CP-201001635
Log # TXNB-10087

SUBJECT: COMANCHE PEAK NUCLEAR POWER PLANT, UNITS 3 AND 4
DOCKET NUMBERS 52-034 AND 52-035
RESPONSE TO REQUEST FOR ADDITIONAL INFORMATION NO. 5116
(SECTION 8.2), 5117 (SECTION 8.4), 5225 (SECTION 2.4.3), AND 5237 (SECTION 17.5)

RESPONSE TO REQUEST FOR ADDITIONAL INFORMATION

Comanche Peak, Units 3 and 4

Figure 2.4.3-204 Paluxy River Basin 3 Probable Maximum Precipitation Two-Thirds Temporal Distribution Hyetograph
(Storm Center at PR Y)

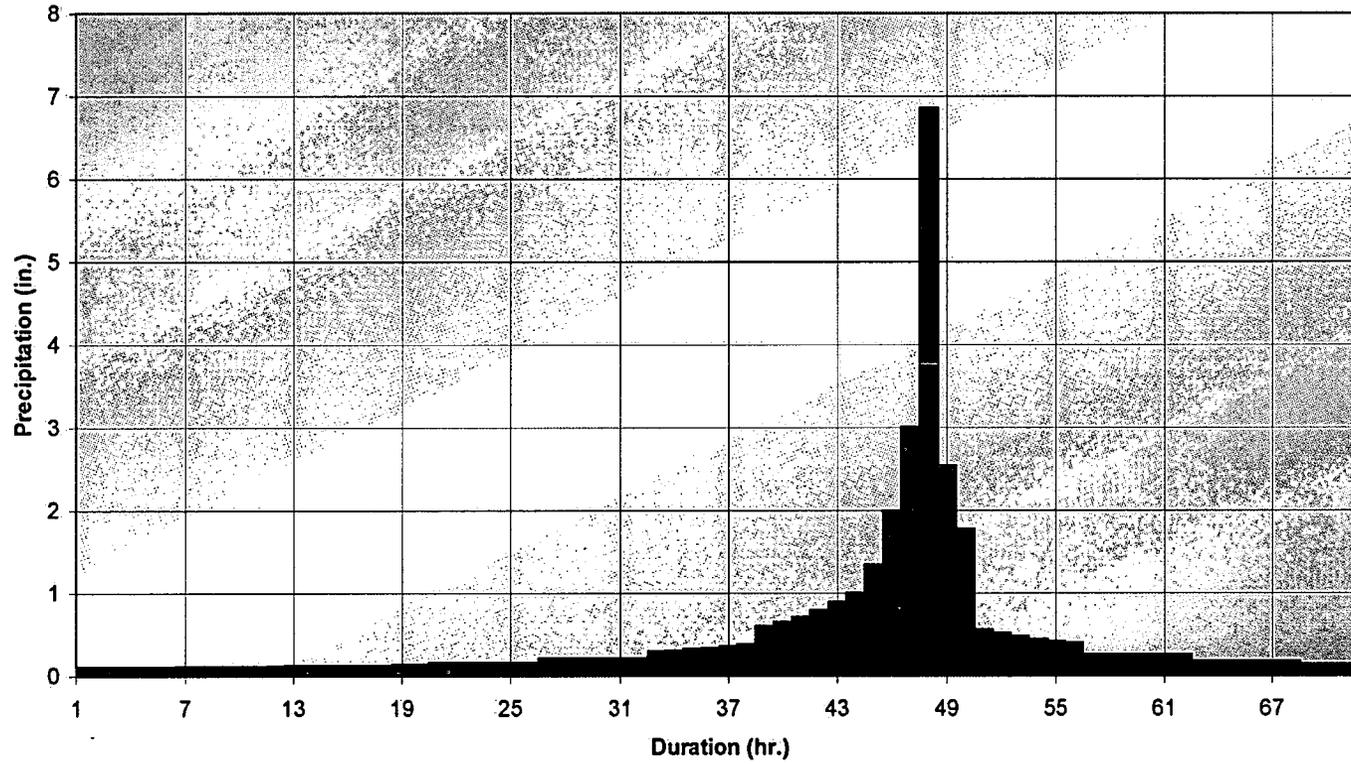
The critical 72-hr storm PMP rainfall total is 35.08 in for the Paluxy River watershed. The standard HMR 52 temporal arrangement of 6-hr precipitation increments is provided in Table 2.4.3-204. The critical temporal distribution was determined by runoff analysis to be a ~~one-third~~two-thirds peaking arrangement for the Paluxy River watershed. The hourly temporal distributions of the 72-hr PMP rainfall for ~~each of the 4 subbasins is~~Basins 3 and 4 are provided in Table 2.4.3-205. The corresponding hyetographs ~~are~~is shown in Figure 2.4.3-204 and 2.4.3-212.
